## SURFACE MINING INSPECTION REPORT

Stevens Creek Quarry lies in a north-northwest trending canyon on the northeast of Monte Bello Ridge in the Santa Cruz Mountains. The access to the mine is off of Stevens Canyon Road, which runs along the west side of the Stevens Creek Reservoir and Stevens Creek County Park. The County approved the current Reclamation Plan, May 2009. The current mining operations occur in two areas commonly referred to as "Parcel A" and Parcel "B". (See Reclamation Plan map Sheet 1.) Parcel A encompasses 51 acres on the southeast side and Parcel B, encompassing a combined 96 acres on the northwest. The mine operations and reclamation plan encompass approximately 147 acres of a 167-acre site. Parcel A is the southeastern portion of the mine and contains the mining operations offices, shops, and maintenance facilities. The County issued a Use Permit in 1996 for recycling concrete, asphalt, and soil; this recycling facility also located on Parcel A.

**SUBJECT: 2015 Financial Cost Estimate - Stevens Creek Quarry  
January 2016 - Supplement to July 2015 FACE  
County Planning Office File #1253-15PAM  
State Mine ID # 91-43-0007**

SURFICIAL SPALLING  
SOUTHEASTERN CORNER  
CUPERTINO,  
CALIFORNIA

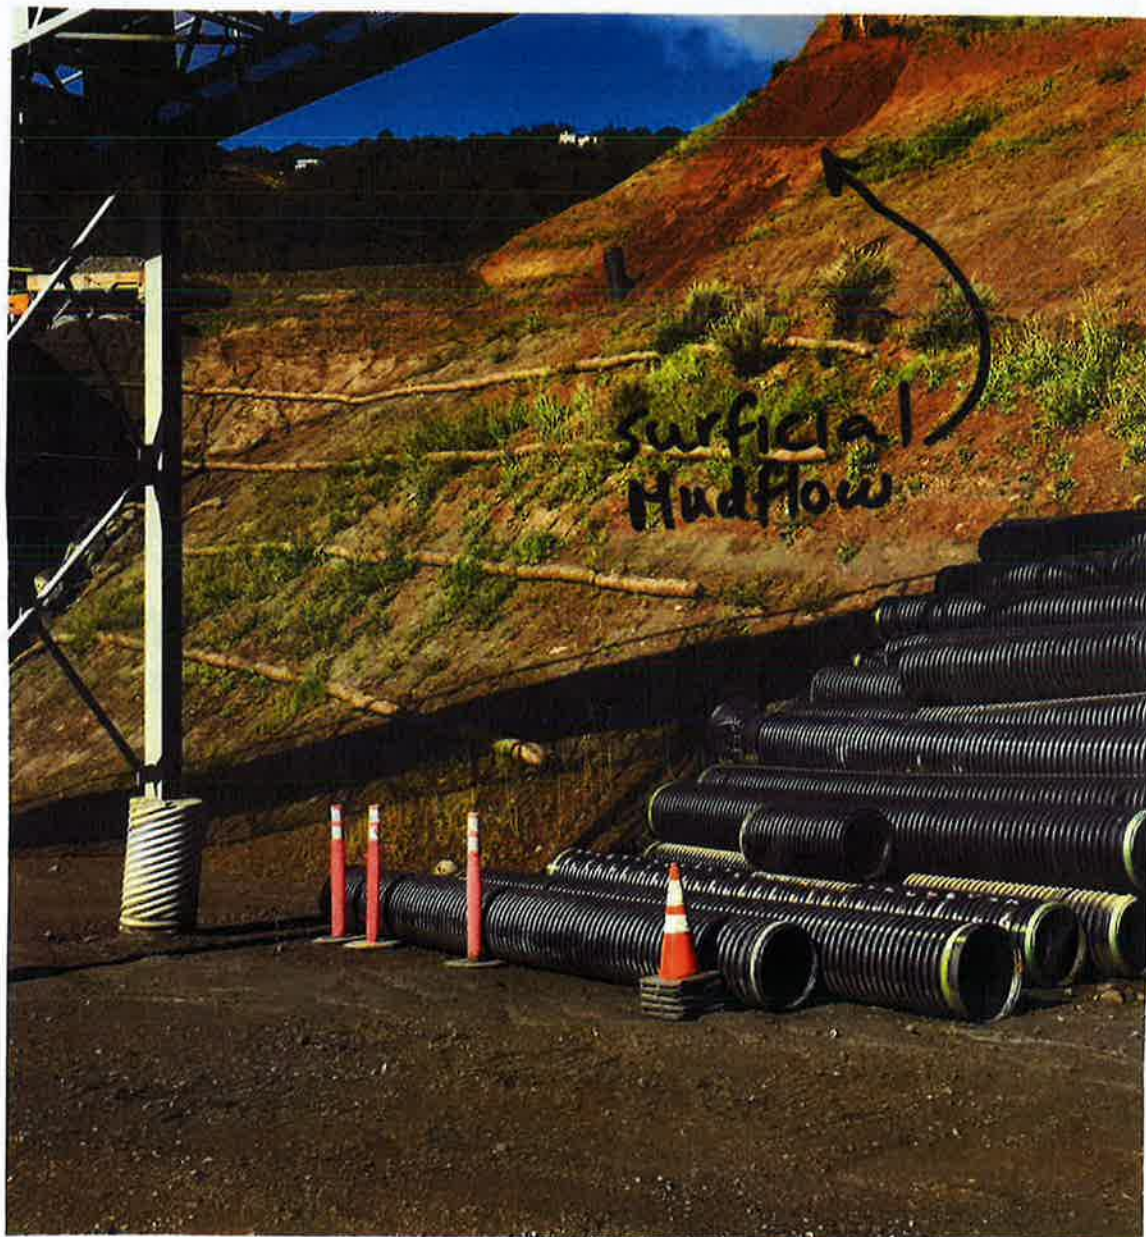
Surficial slumping was also observed in the area of the PG&E wooden monopole where the cut slope forms a south-facing section. The slumping is ongoing as portions of sheared greenstone bedrock that is highly and closely fractured detach and crumble as they fail. See Figure 9, Surficial Spalling Southeastern Corner.

**Plate 10**

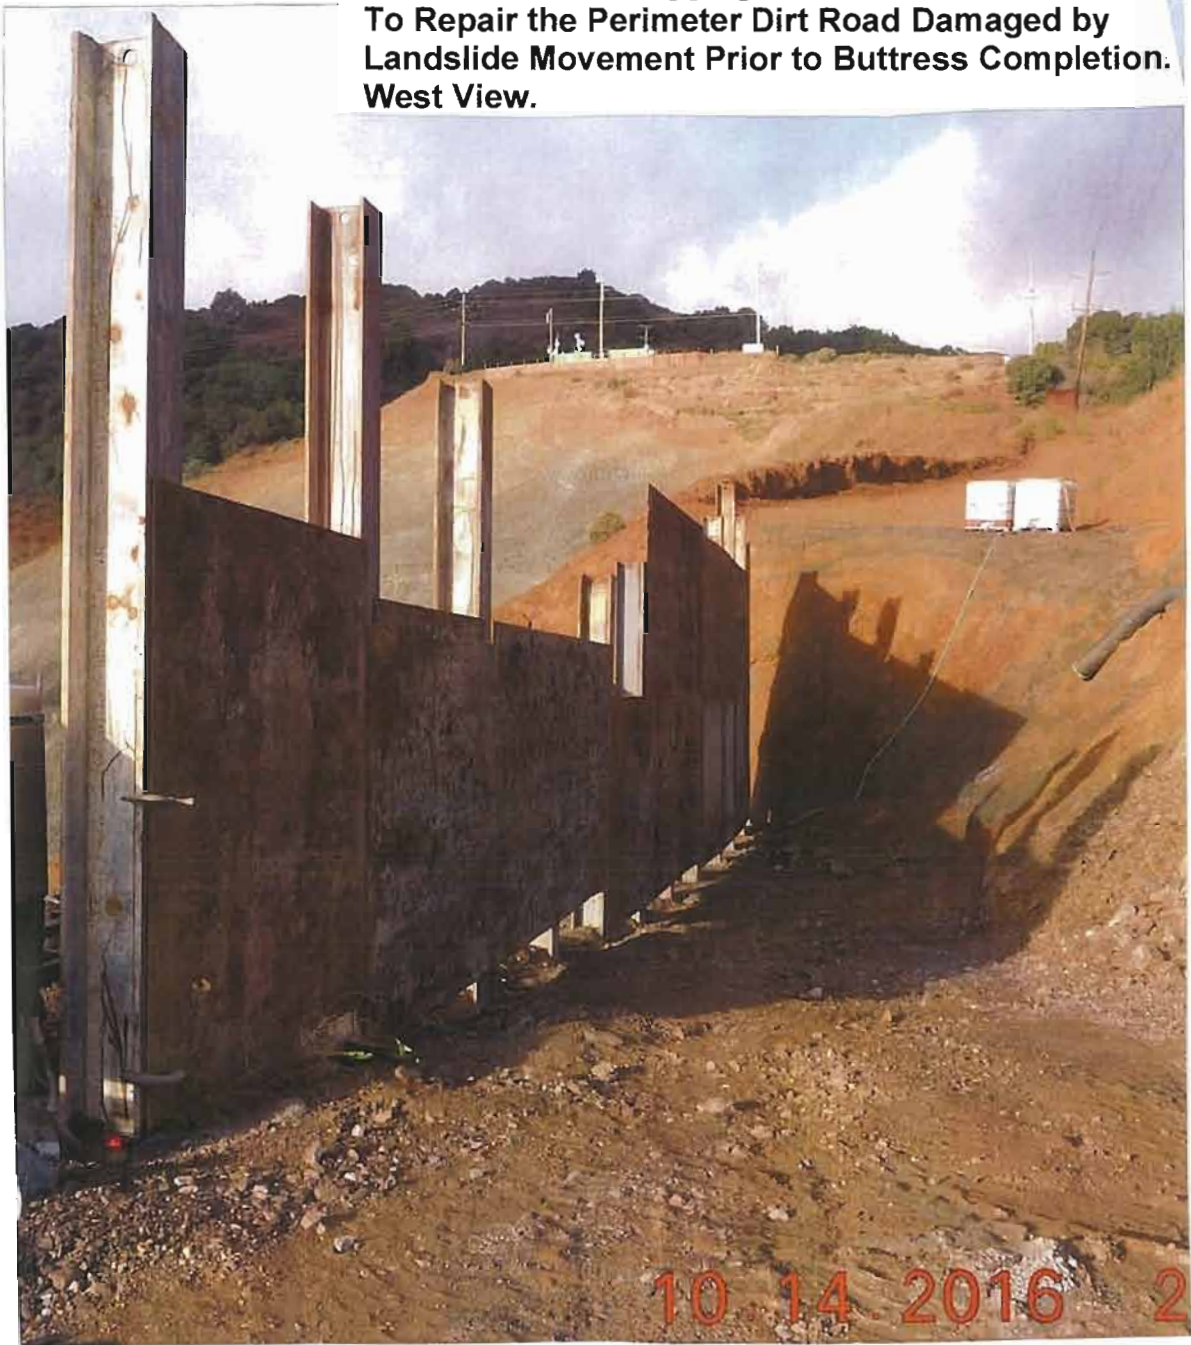
- The upper portion of the landslide along the central section of the Northern Slope has mobilized significantly, encroached onto the perimeter dirt road and damaged it preventing westward access. A soldier pile wall with steel sheet metal welded onto steel I-beams had been constructed along the downslope side of the perimeter dirt roadway so that fill can be placed upslope of the wall to reestablish the road level. Recent soil cracking was observed on the downslope side of the concrete piers supporting the wall. No recent cracks appear to have occurred upslope of the soldier pile retaining wall pier line. Open soil cracks marking the top of the slide had formed before the installation of the wall. See Site Photographs, Plates 10 and 11.

**Plate 11**

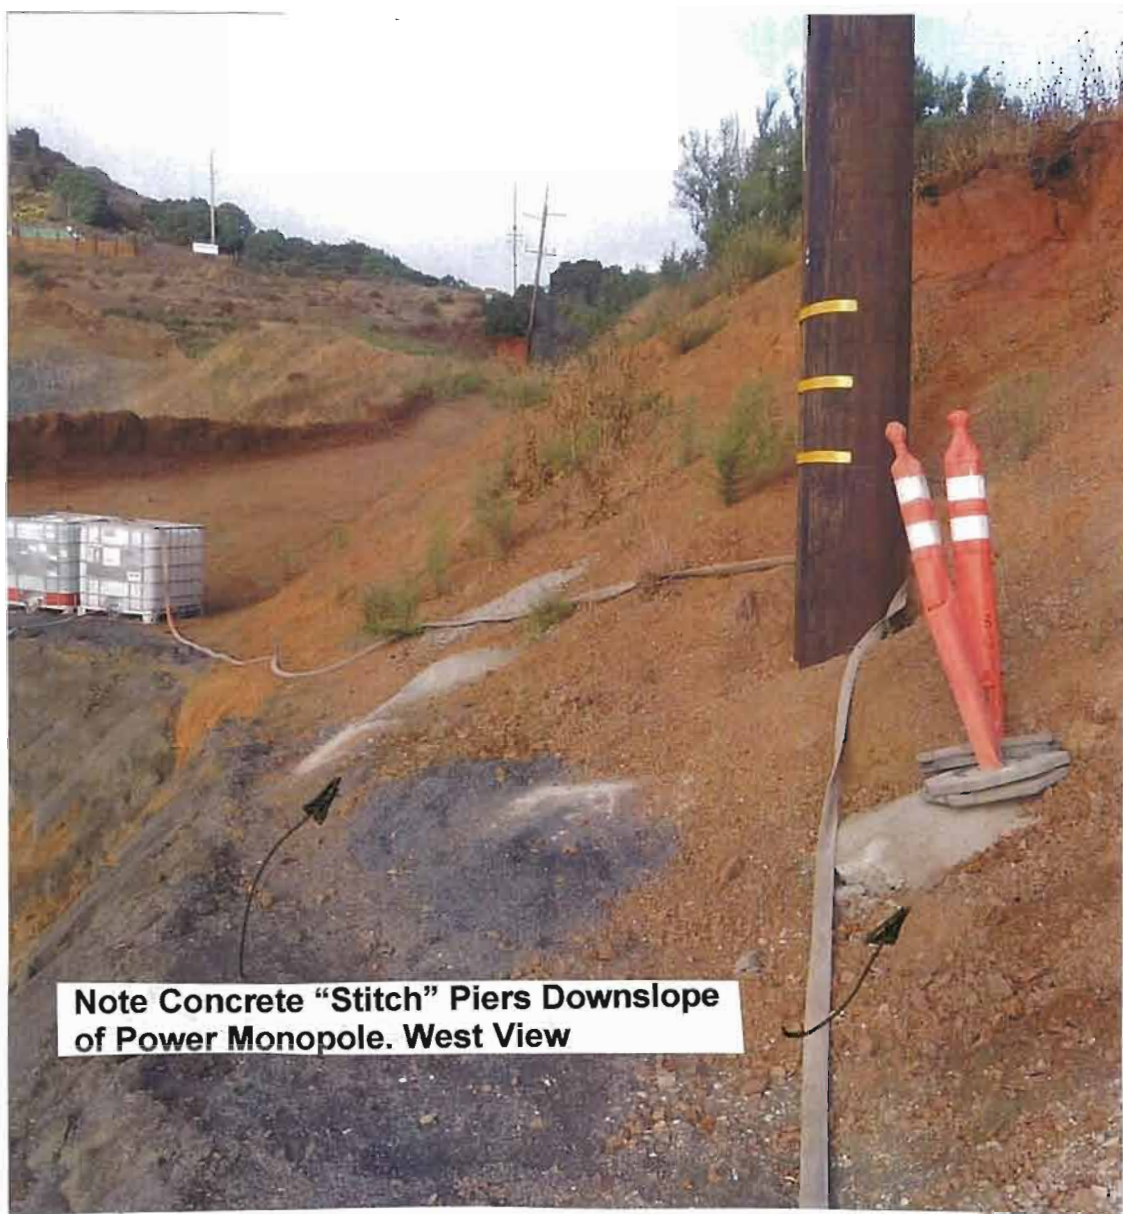
The upper central portion of the landslide deposits that were actively moving upslope of the top of the buttress as it was being constructed encroached on the dirt perimeter road and damaged it. In response and as noted above, a soldier pile wall with sheet metal lagging and supported on piers exceeding 30 feet in depth was constructed along the downslope side of the roadway where it was damaged and fill was placed along the north side of the wall to restore the roadway. A line of "stitch" piers has also been constructed immediately downslope of the PG&E wooden monopole located near the top of the slope. If a strong seismic event occurs and even if portions of the Northern Slope fail and impact the perimeter roadway restoration measures will be implemented by the quarry maintenance crews. Since the fill buttress has been raised to blanket the Northern Slope, landslide movement and reactivation that has been ongoing for years will most likely cease and migration of cracking farther to the north is considered unlikely. No tilting, separation, line and/or insulator sagging or tensioning has not been reported since the completion of the buttress and the construction of the concrete "stitch" piers downslope of the power pole.
